Rear Door Cinching Actuator Freezing in Cold Weather

Classification Repair Bulletin **Section/Group** 11 - Closures **Country/Region** All

Year 2016-2017 **Model** Model X **Version** All

Figure 1 (Cutout for drain hole)

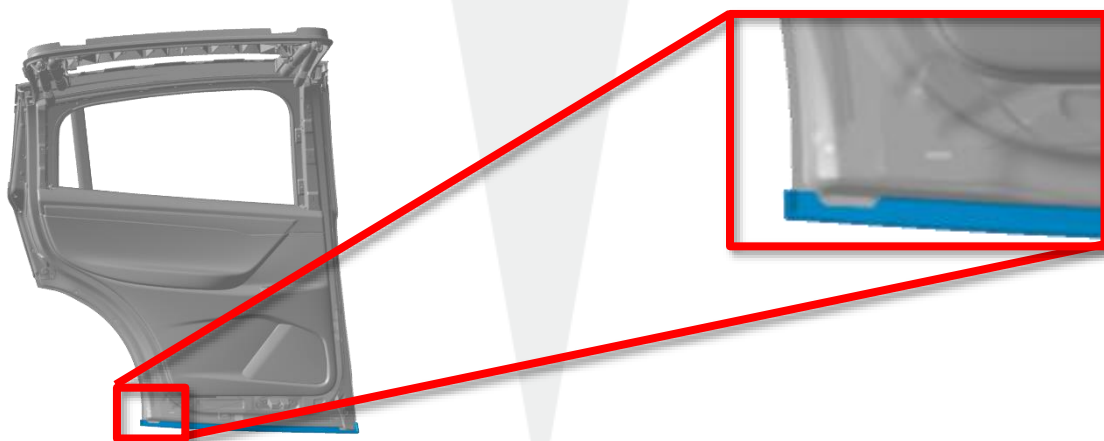
1. Check the lower edge protector (Figure 1):
 - If the rear of the lower edge protector has a cutout for the drain hole in the door shell, skip to the "Replacing the Latch and Cinching Actuator" section of this document.
 - If the rear of the lower edge protector does not have a cutout for the drain hole in the door shell, continue to the next step.

Figure 2

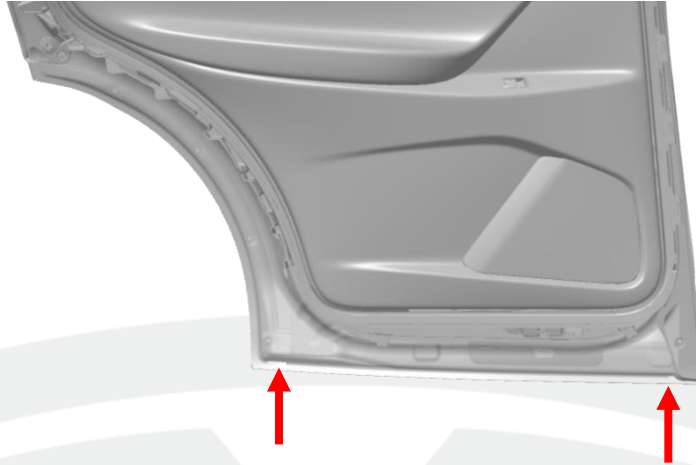
3. Remove any debris that obstructs the drain holes in the door shell (Figure 2).

Figure 4

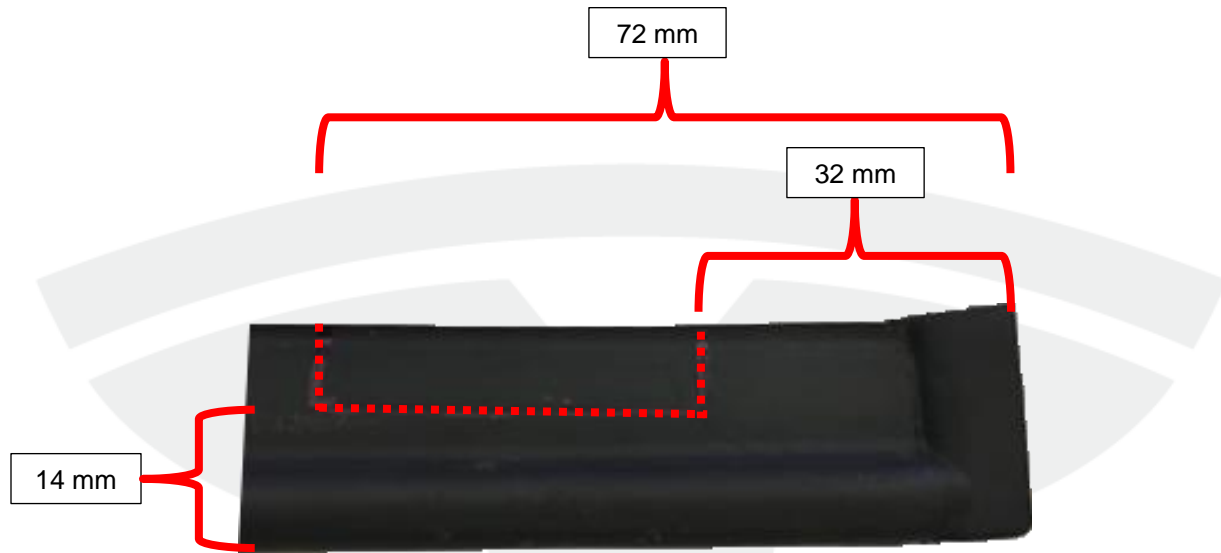
7. Mark an area at the rear of the edge protector (Figure 4):
 - a. Mark a vertical line 72 mm from the rear edge.
 - b. Mark a vertical line 32 mm from the rear edge.
 - c. Mark a horizontal line 14 mm from the bottom edge.

8. Use a precision knife to cut the area that was marked in the previous step.
9. Install the modified edge protector.
10. Continue to the "Replacing the Latch and Cinching Actuator" section of this document.
